Re: Turkey Point Units 3 and 4
Docket Nos. 50-250 and 50-251
St. Lucie Units 1 and 2
Docket Nos. 50-335 and 50-389
Topical Quality Assurance Report (FPLTQAR 1-76A)

Florida Power & Light
Topical Quality Assurance Report
Change Summary
June 2002
(Page 1 of 2)

Summary of changes to the Florida Power & Light Topical Quality Assurance Report (FPL TQAR 1-76A) since June 2001.

TOPICAL QUALITY ASSURANCE REPORT	REVISION 40 (DRAFT A) (R1053)
ORGANIZATION OF DEPARTMENTS AFFECTING QUALITY FIGURE 1-1 APPENDIX A NUCLEAR DIVISION	07/11/01
	PAGE 1 OF 2

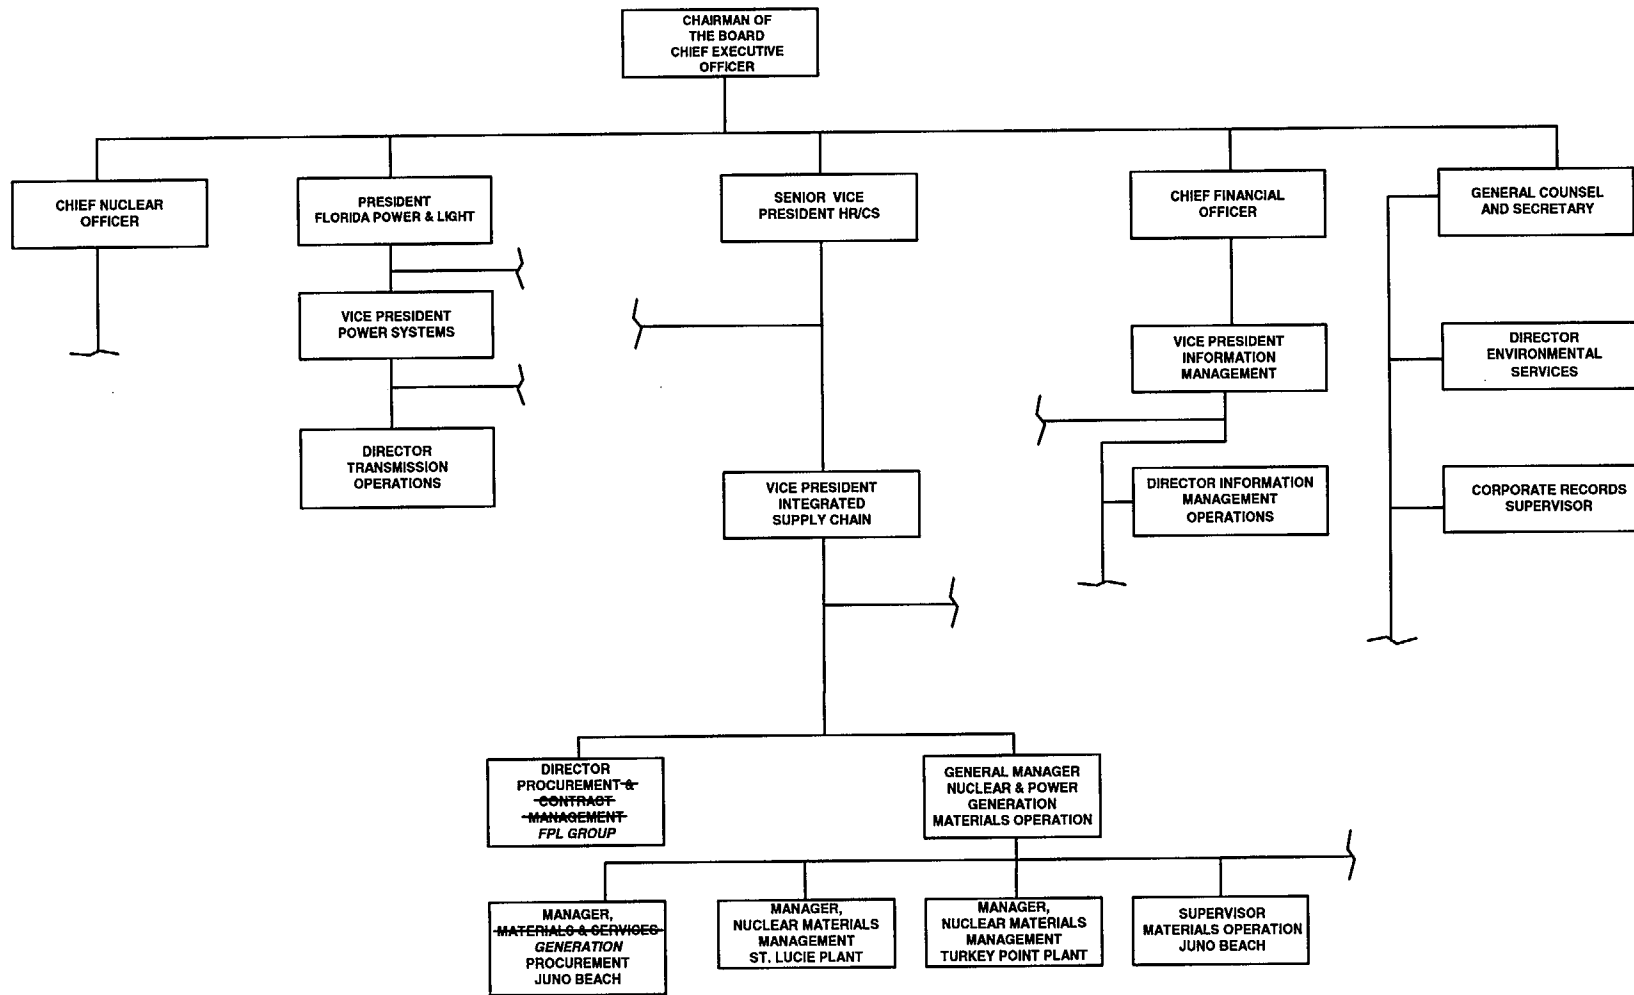
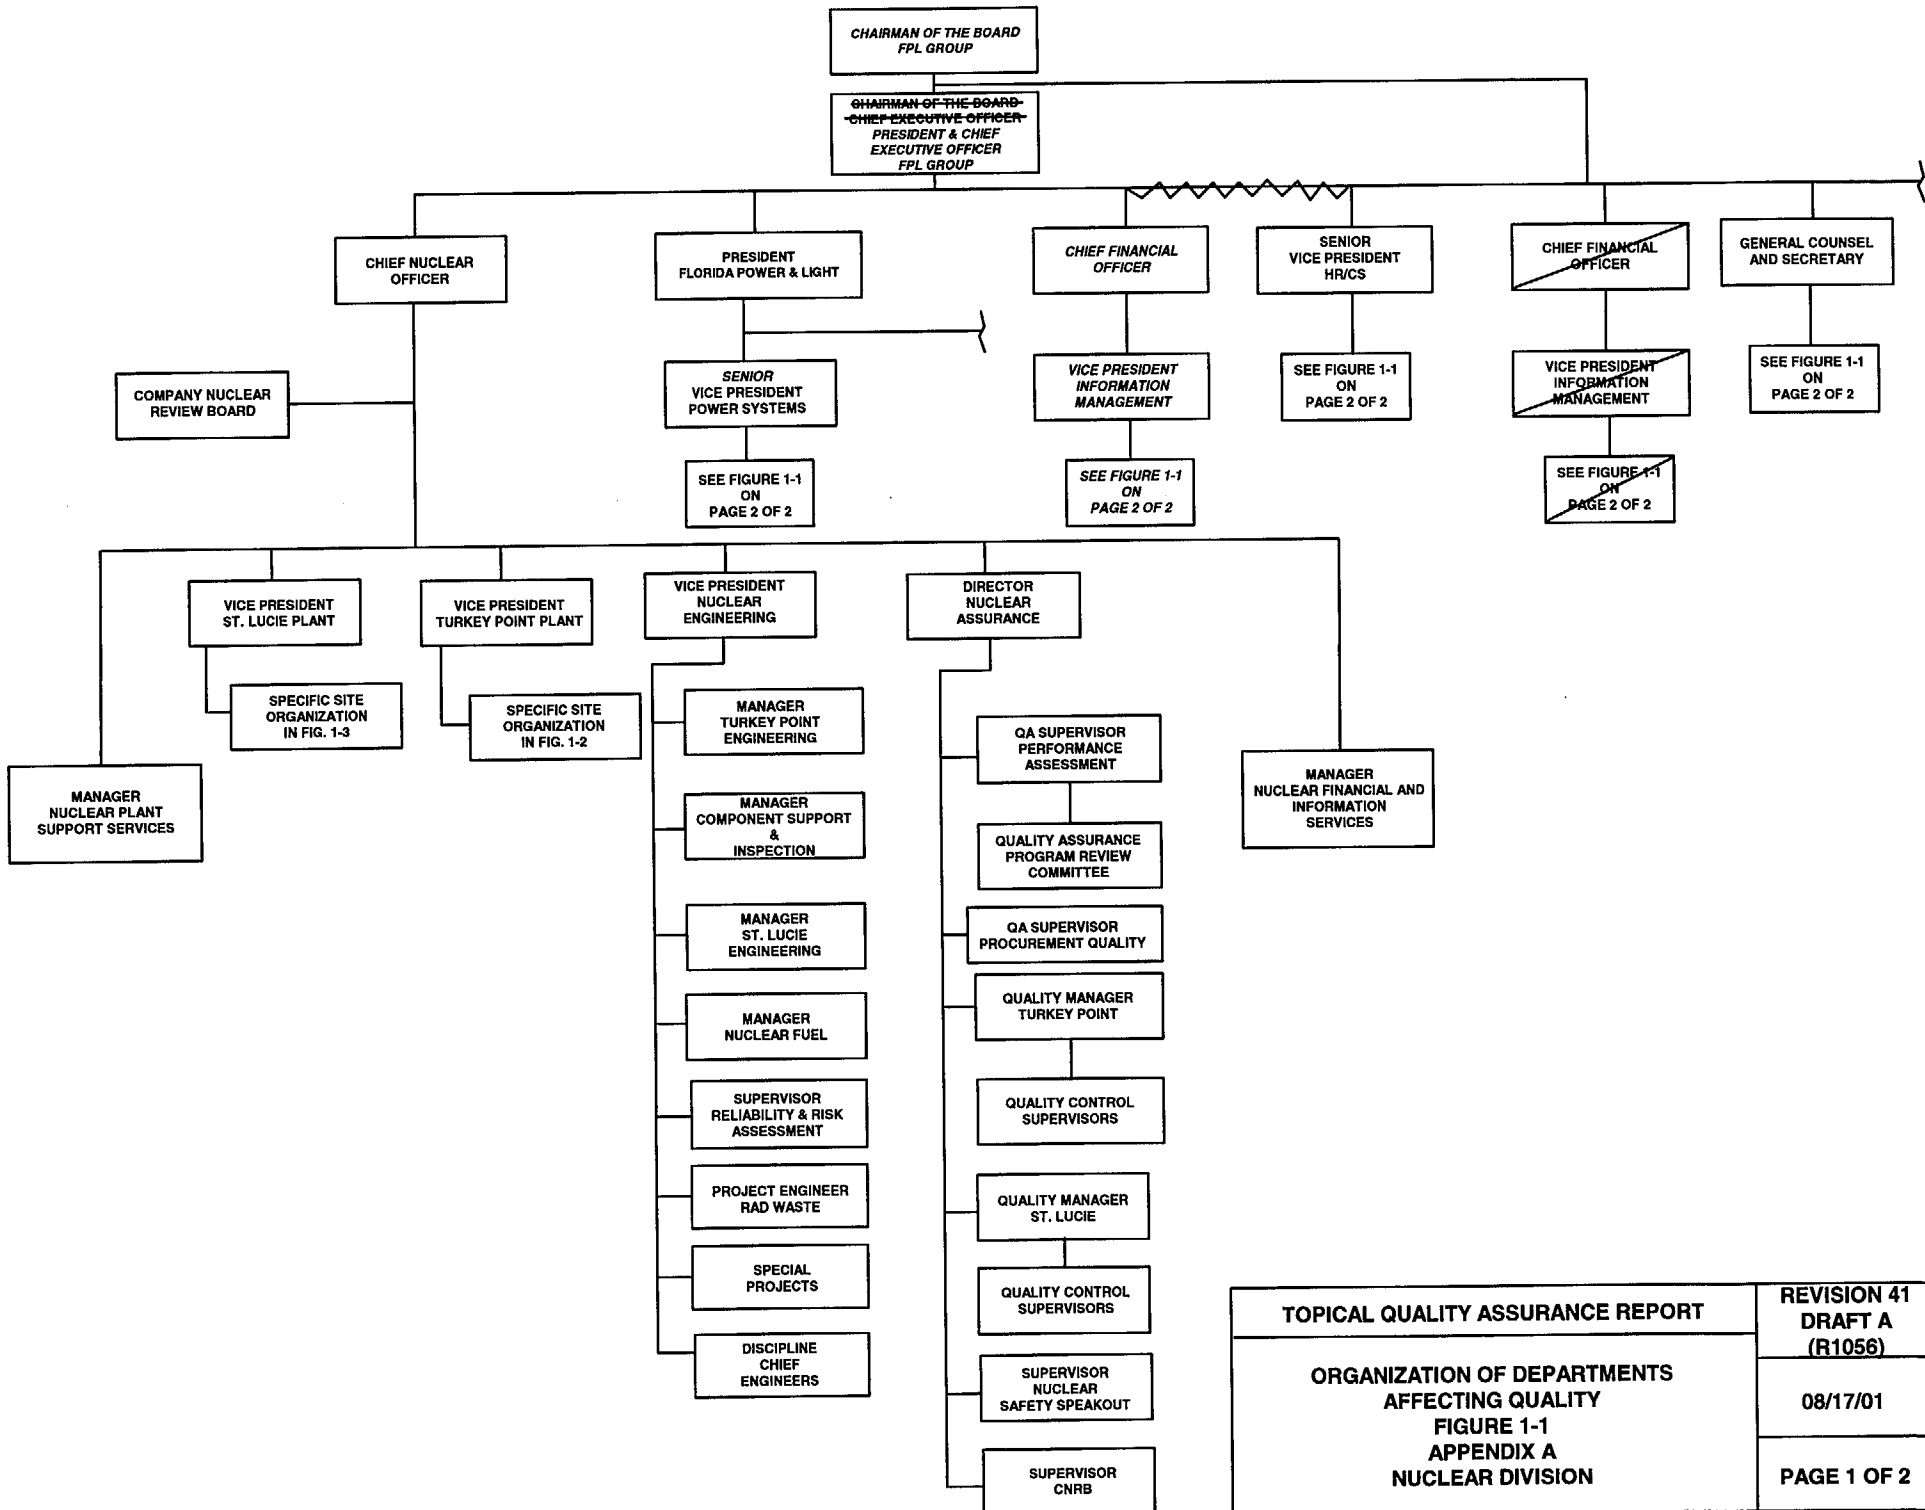
5. APPENDIX A, FIGURE 1-1:
ORGANIZATION OF DEPARTMENTS AFFECTING QUALITY
(Rev. 39 to Rev. 40)

Update titles in the Integrated Supply Chain organization.

TOPICAL QUALITY ASSURANCE REPORT	REVISION 41 DRAFT A (R1056)
ORGANIZATION OF DEPARTMENTS AFFECTING QUALITY FIGURE 1-1 APPENDIX A NUCLEAR DIVISION	08/17/01
	PAGE 1 OF 2

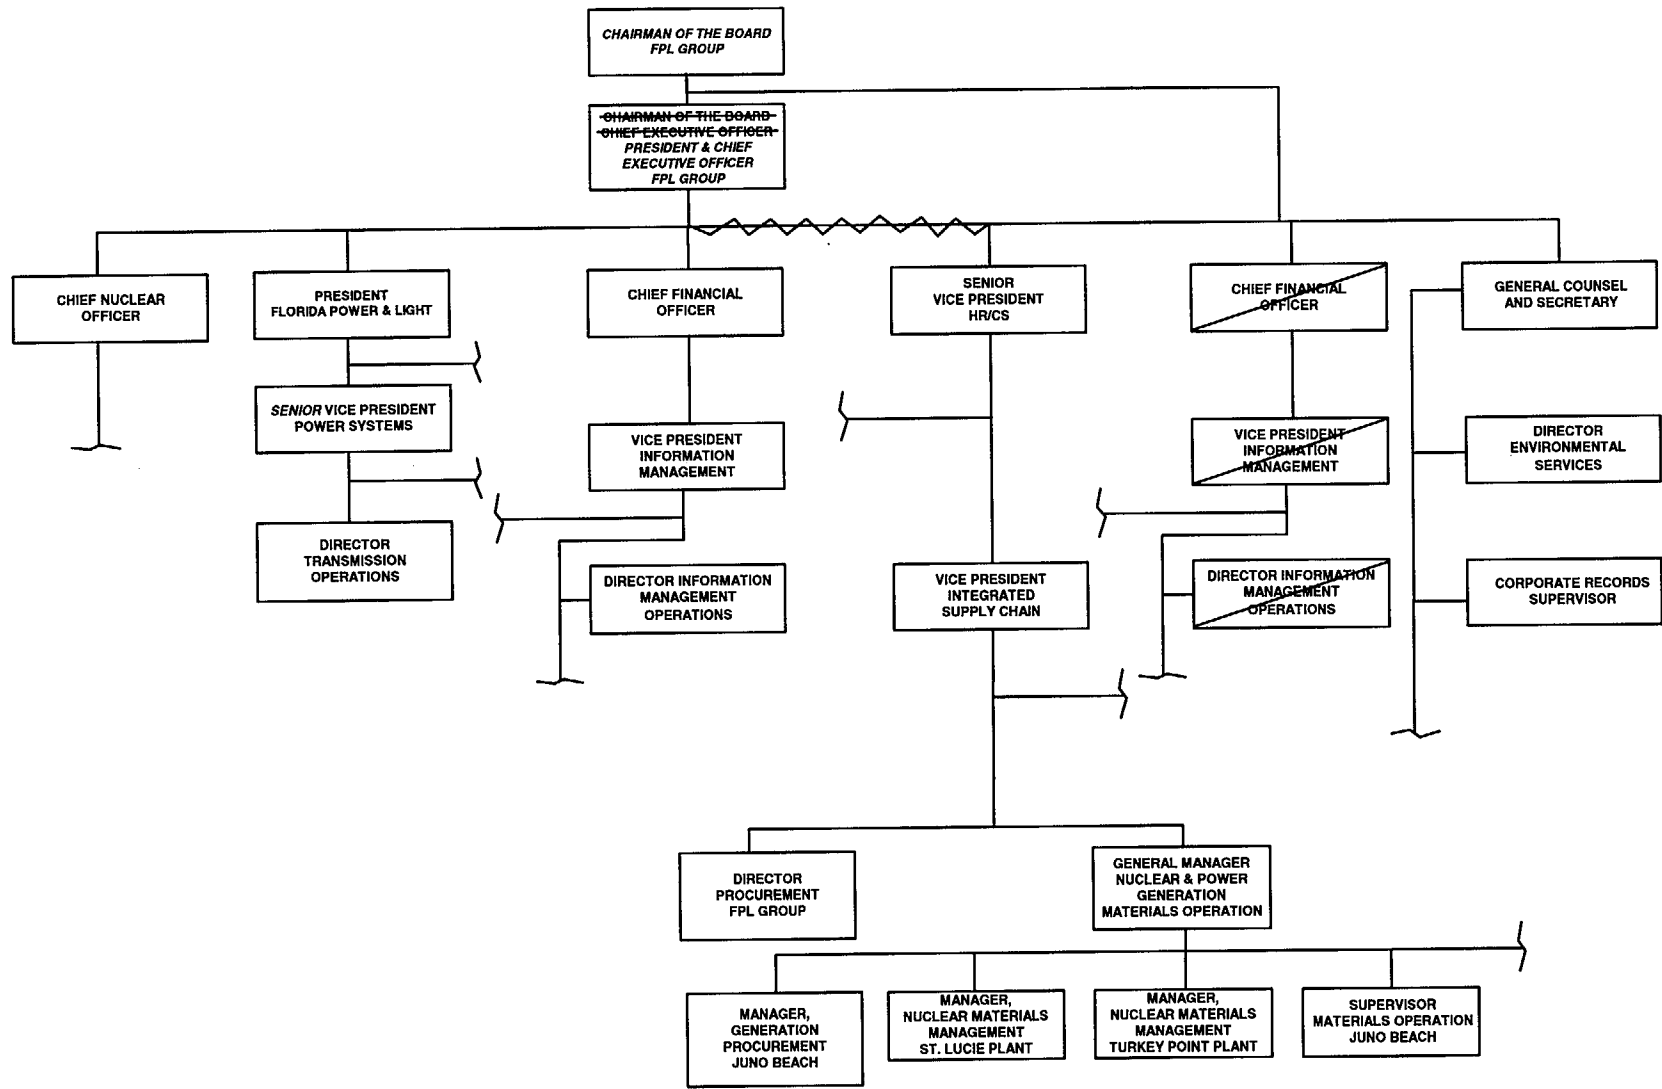
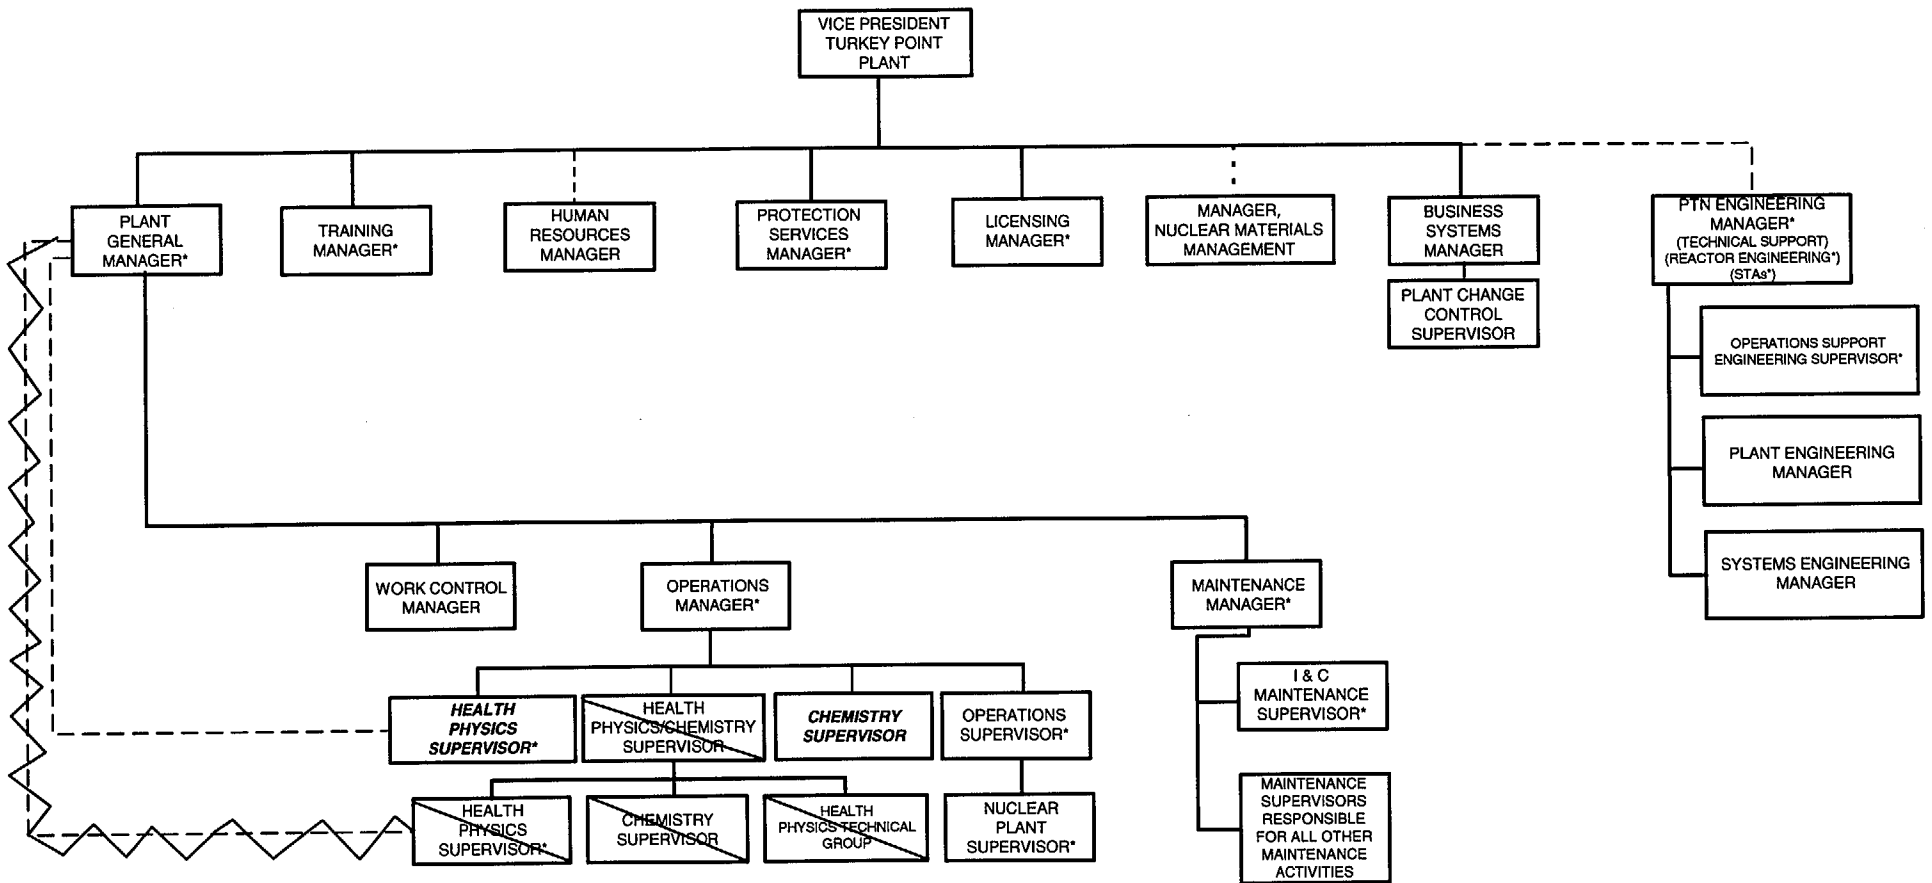
6. APPENDIX A, FIGURE 1-1:
ORGANIZATION OF DEPARTMENTS AFFECTING QUALITY
(Rev. 40 to Rev. 41)
